Public Works Department – Engineering Division

ADDENDUM NO. 4

PROJECT 5067 WTP FILTER IMPROVEMENTS AND HYPOCHLORITE CONVERSION

C:\Dropbox (TJCAA)\W Drive- CADD from Sharepoint\2022 Projects\122044 - PMP Filter Improvements\03 Addendum\Stru\S308.dwg 3--28--24 04:34:16 PM BeeVue

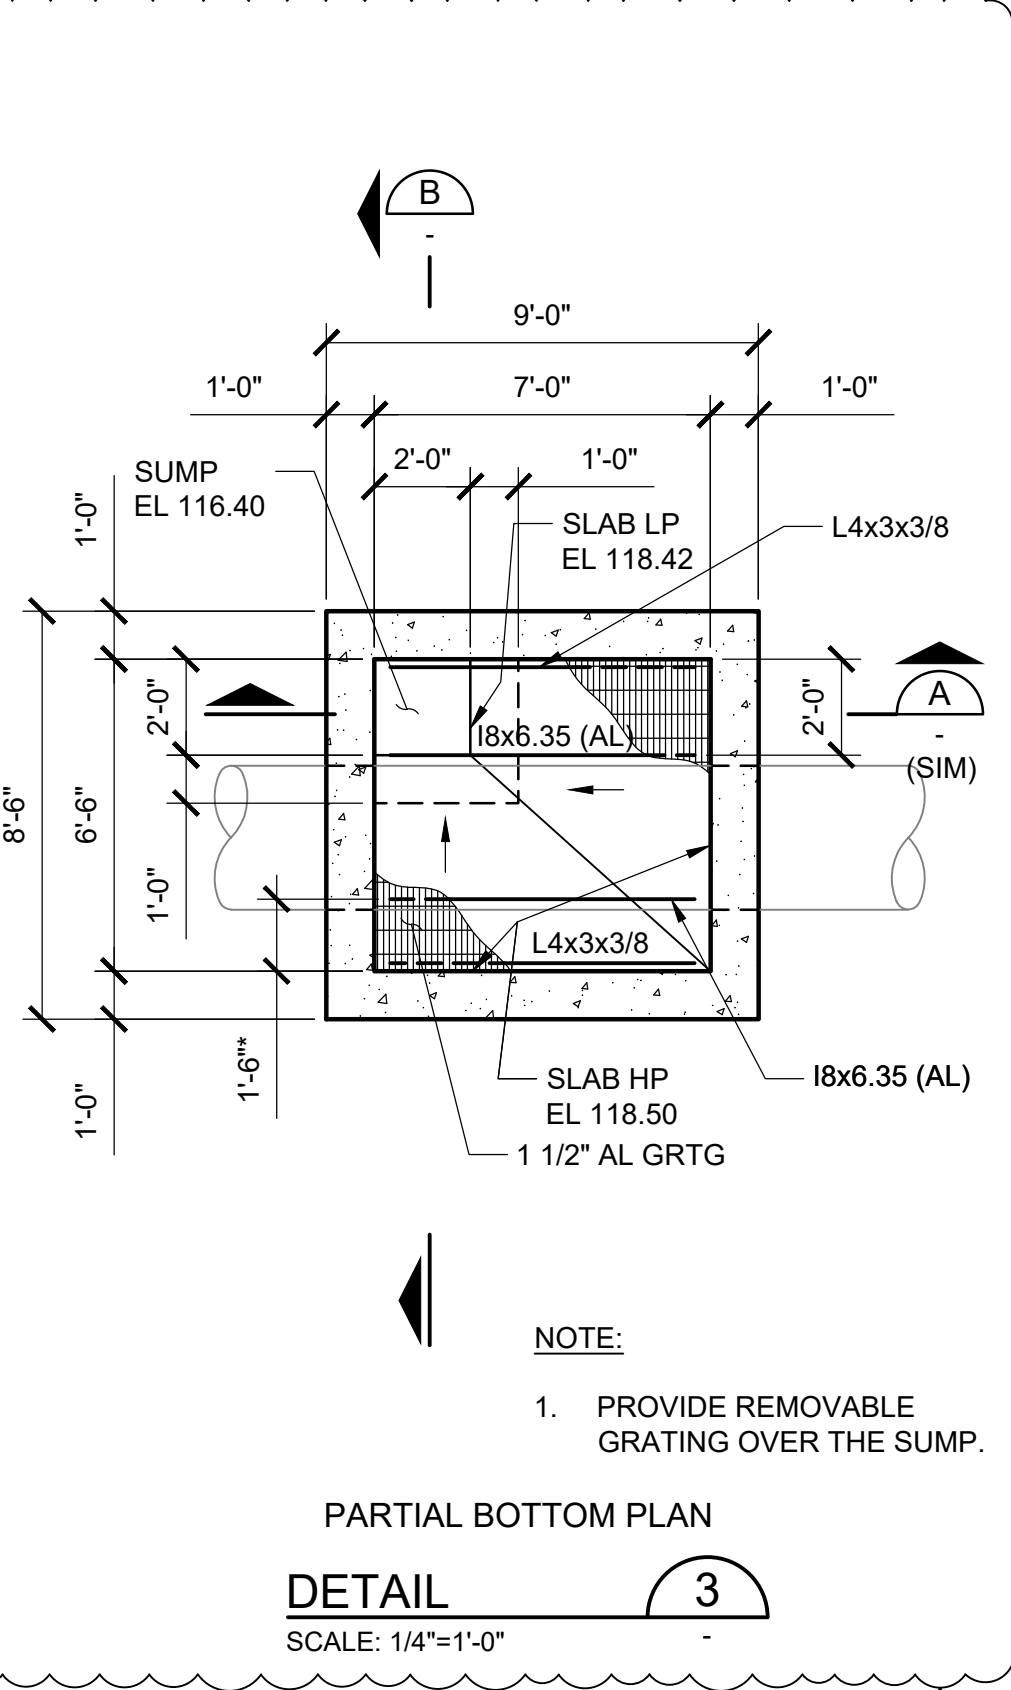
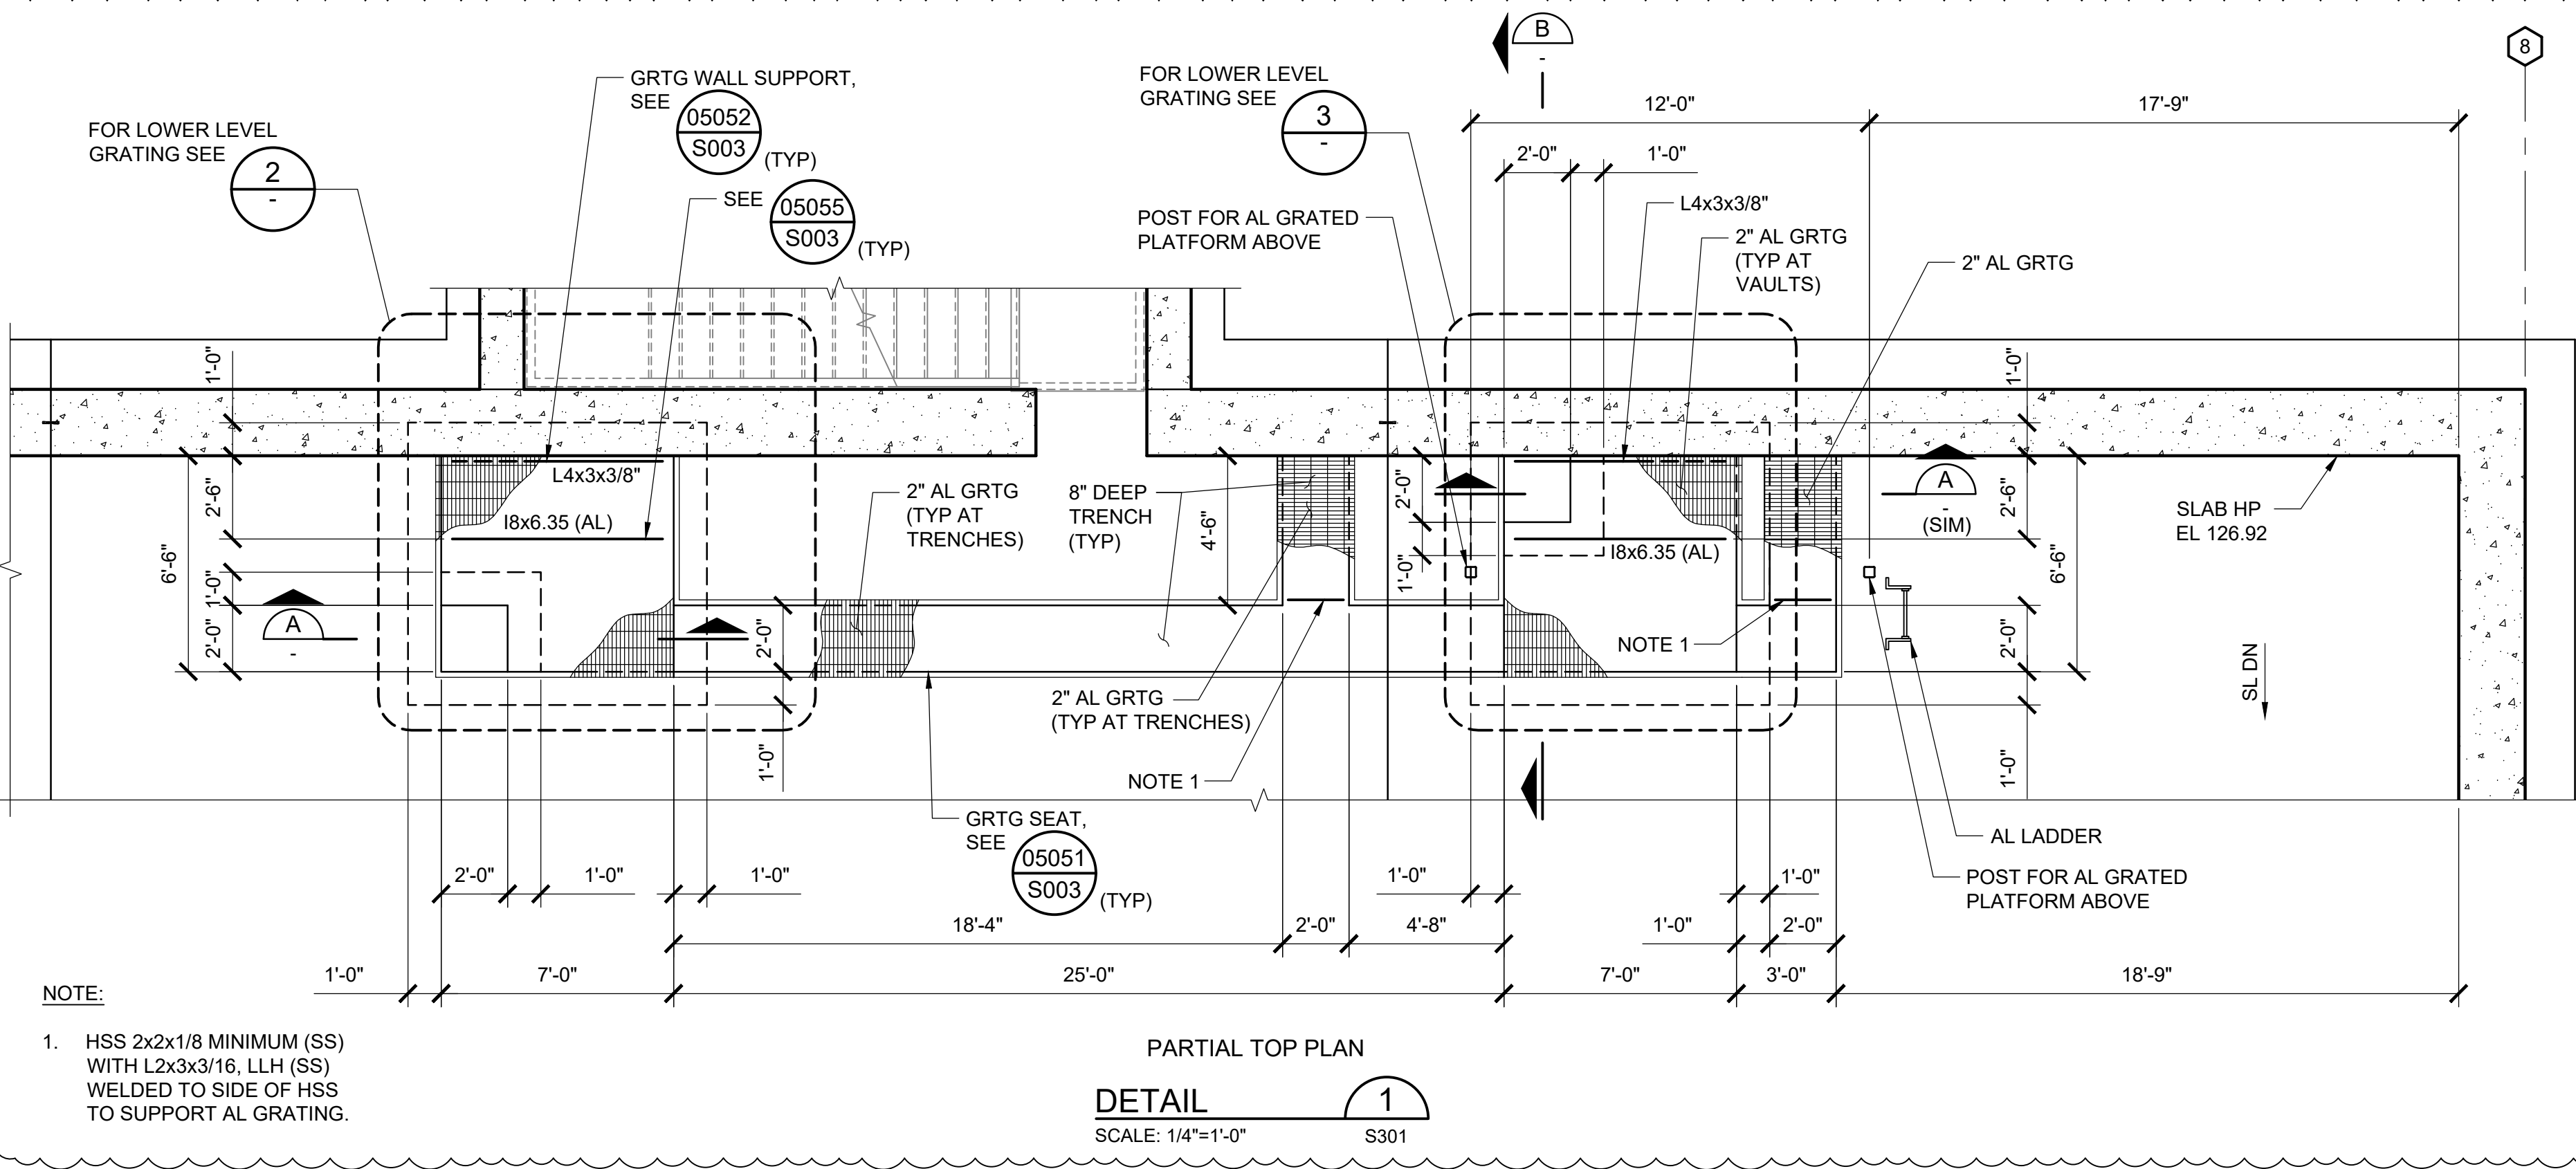
13. Replace Drawing C103 with the attached updated drawing C103.
14. Replace Drawing S308 with the attached updated drawing S308.
15. In Section 40 05 10, Part 2.2.N.1.b, add the following "Steel Plate Fabricators Association (SPFA) Quality Certification Program for Steel Pipe and Accessory Manufacturers, or the Lloyd's Register Quality Assurance" after "...shall conform to the requirements of ANSI/AWWA C200 and ISO 9001:2005 Certificate of Quality System Registration"

13. Contract drawing M313 calls out removable grating TYP see Structural drawings inside the CFE injection vaults, however there are no details in the structural

drawings indicating removable grating inside the injection vaults. Please provide the required details.

Response: Please see updated drawing S308 in this addendum, Item A.14.

DWG. NO.
S310

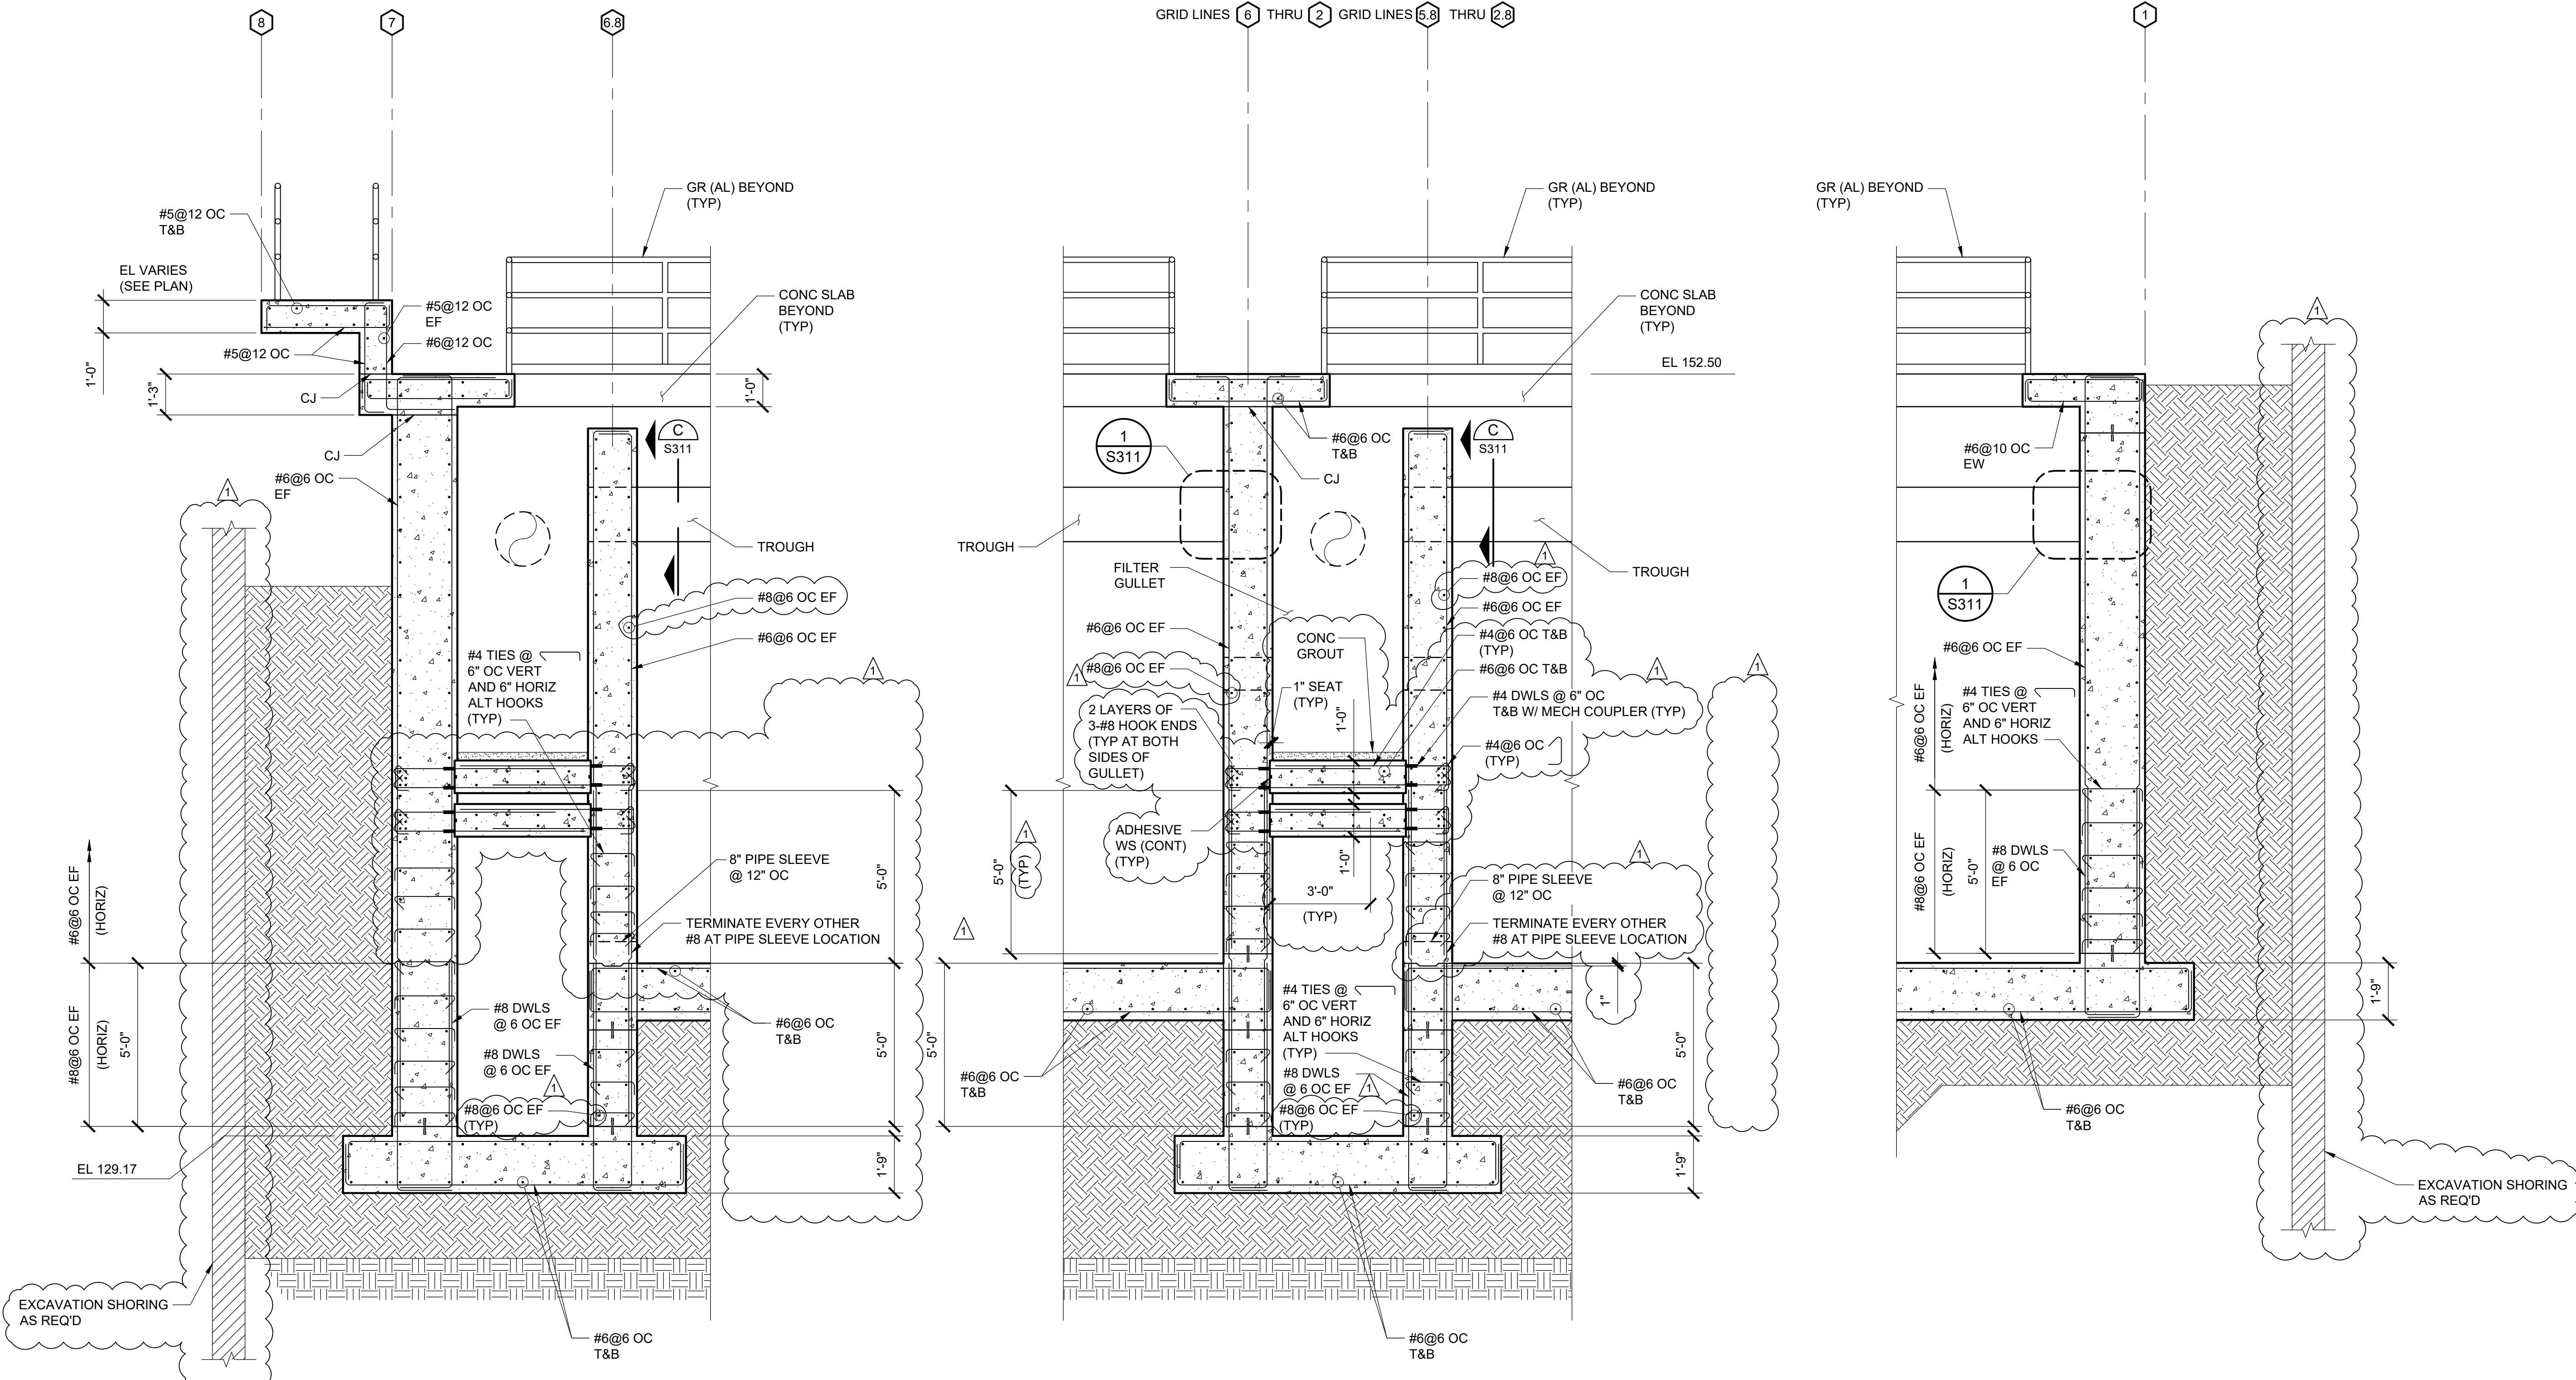
24. Replace Drawing S302 with the attached updated drawing S302.
25. Replace Drawing S310 with the attached updated drawing S310.
26. Replace Drawing S643 with the attached updated drawing S643.

66. Reference sheets S306, S310, and M307. Sections B/S306 and 1/S310 show the filter plenum/gullet north of filter 6 with no intermediate concrete decks. Section C/M307 shows intermediate concrete decks at this filter plenum/gullet. Which is correct? Please advise and revise drawings accordingly.

72. Specification section 31 50 00 Item 3.2 A. states "Due to site space constraints, sloping and benching systems for exposed faces of excavation may not be utilized". Drawing S305 and S306 depict the excavations for the new filters as having sloped sides. Please clarify if sloped excavations are allowed.

75. Drawing M307 includes a callout indicating, 8" Dia. PVC Sleeve, Typ. @12" Center EL 134.5. Details 1 & 2 on S310 call for #8 reinforcing @ 6" OC, both vertically and horizontally and at each face, as well as #4 ties @ 6" OC at the elevation of the 8" PVC Sleeves in these walls. Please provide a drawing which details the combination of the indicated reinforcing steel in these walls, and the 8" sleeves at 12" centers at elevation 134.5.

Response: Section C/M307 is correct. Sections B/S306 and 1/S310 shall be revised to show intermediate concrete decks for the filter plenum/gullet north of filter 6. See this addendum, Item A.25. Please note that Drawing S306 is similar and will be updated as part of developing the Conformed Documents.

Response: Specification is to be followed. See attached updated Drawing S310 in this addendum, Item A.25 depicting Excavation Shoring, as required for construction. Please note that Drawings S305 and S306 are similar and will be updated as part of developing the Conformed Documents.

Response: See attached updated Drawing S310 and this addendum, Item A.25.
